**Planning & Environment**
Issued under the Environmental Planning and Assessment Act 1979
Approved Section 4.55 (.....) Modification Application
No. 3 granted on the 8 May 2019
in respect to SSD 7484
Signed AD
Sheet No. 1 of 33

PROJECT
**SANDSTONE
PRECINCT**
23-39 BRIDGE STREET, SYDNEY 2000, AUSTRALIA

PROPOSED SITE PLAN

DRAWING NUMBER
SP-DA-G-1500

**LANDS BUILDING - LEVEL 09,
EDUCATION BUILDING -
LEVEL 08**

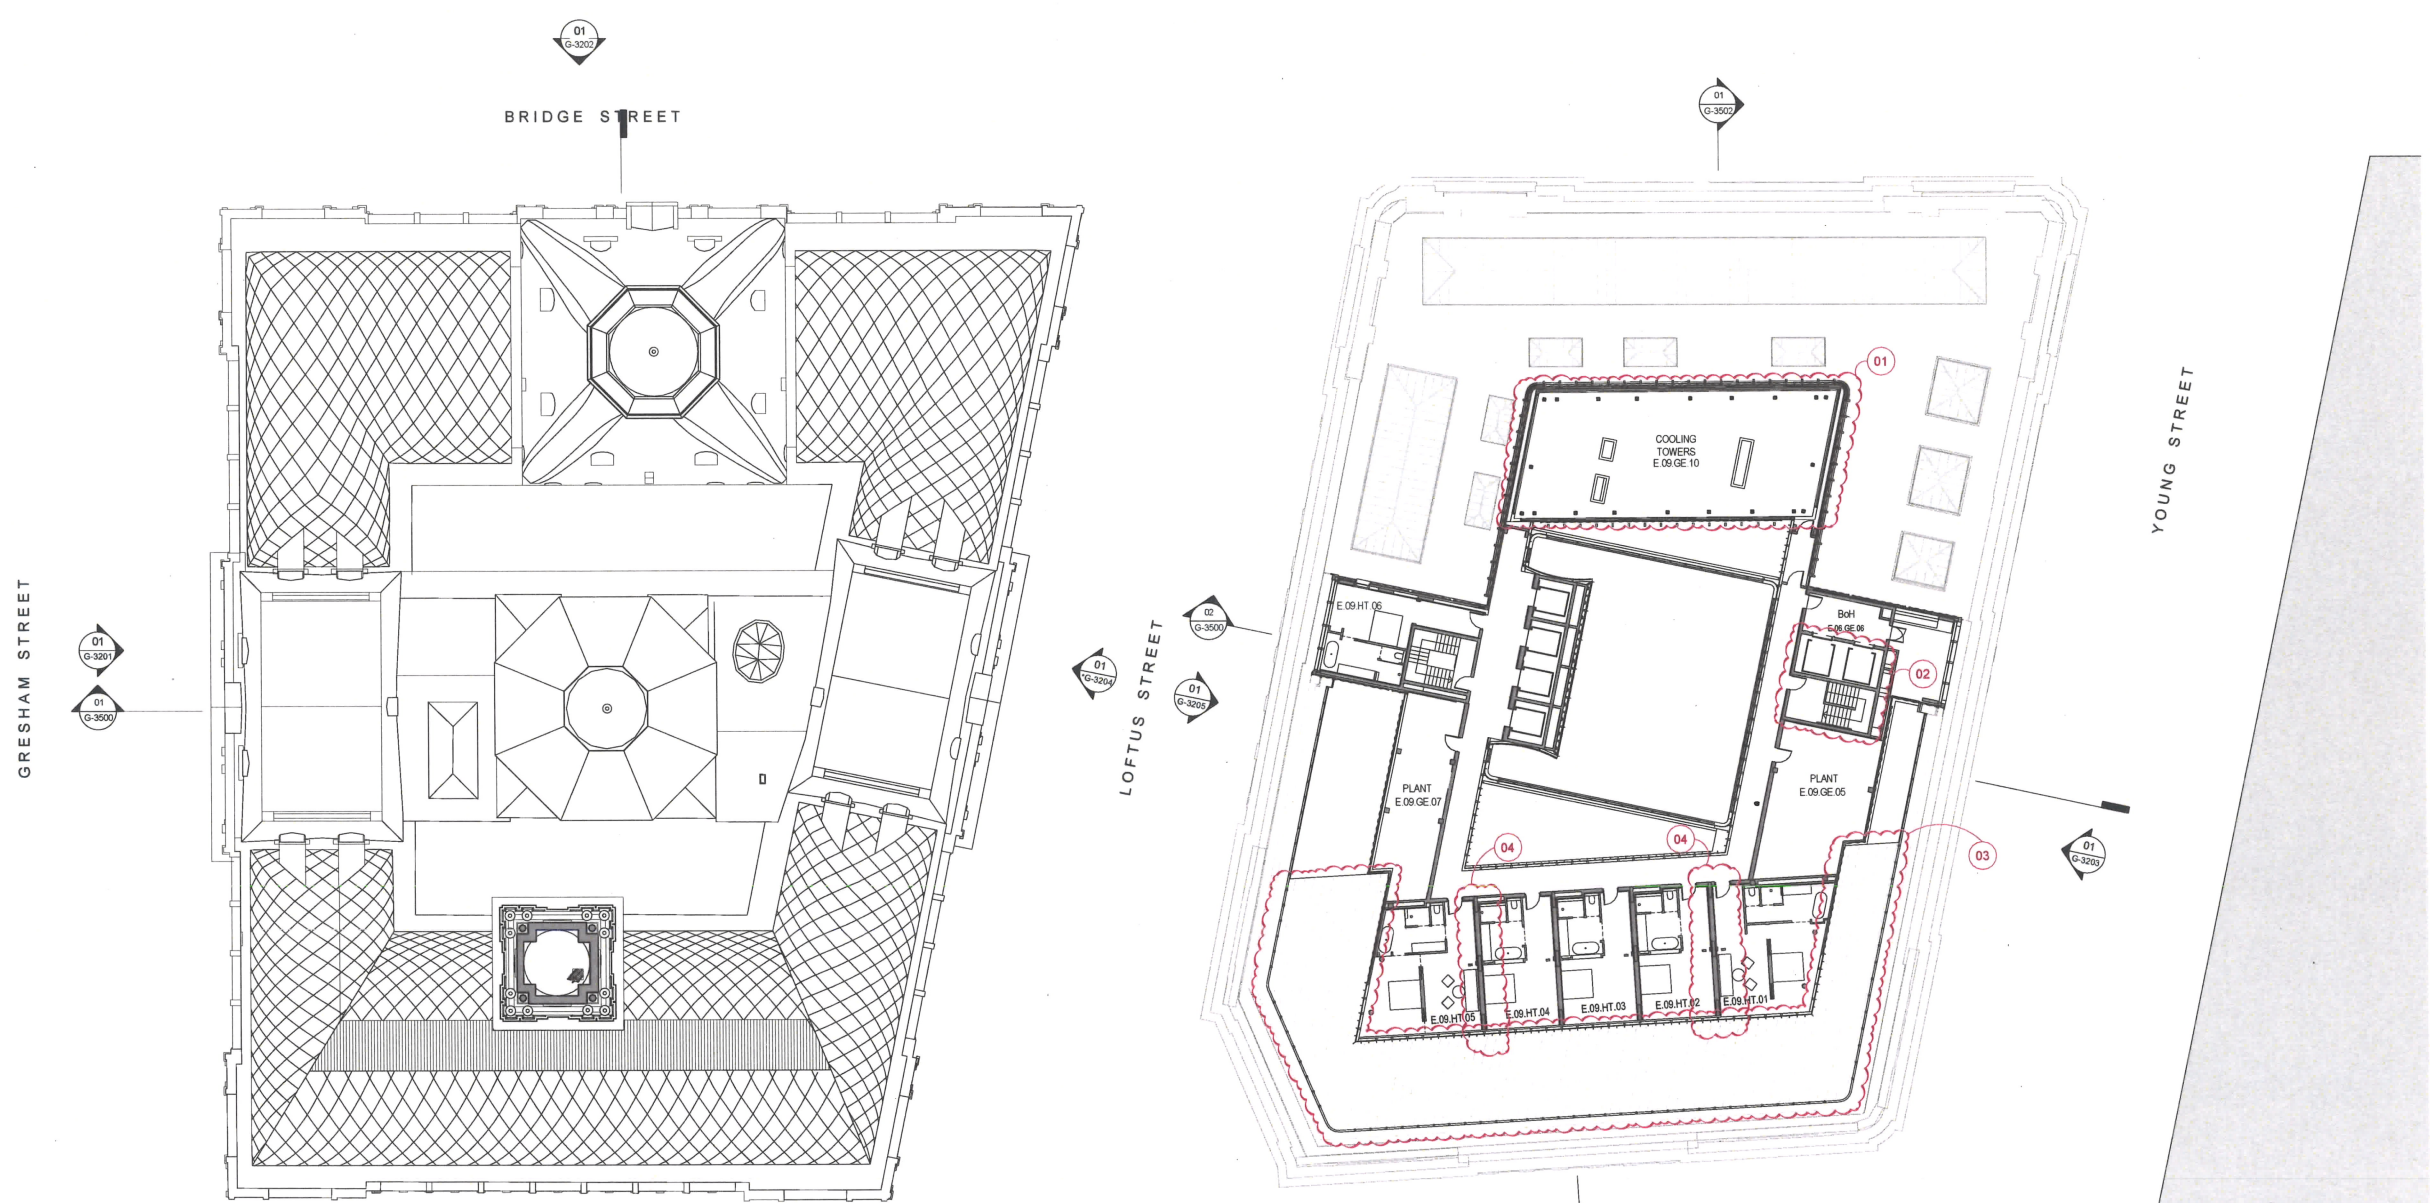
- CHANGES LEGEND:
- 01 FACADE EXTENDED SOUTH TOWARDS
COURTYARD. ADDITIONAL GUESTROOM
ADDED.
 - 02 BOH LIFTS AND HOUSEKEEPING
RELOCATED NORTH.
 - 03 COOLING TOWERS MOVED TO LEVEL 9
AND REPLACED WITH 3 ADDITIONAL
GUESTROOMS.
 - 04 ADDITIONAL KEY PER ZONE.
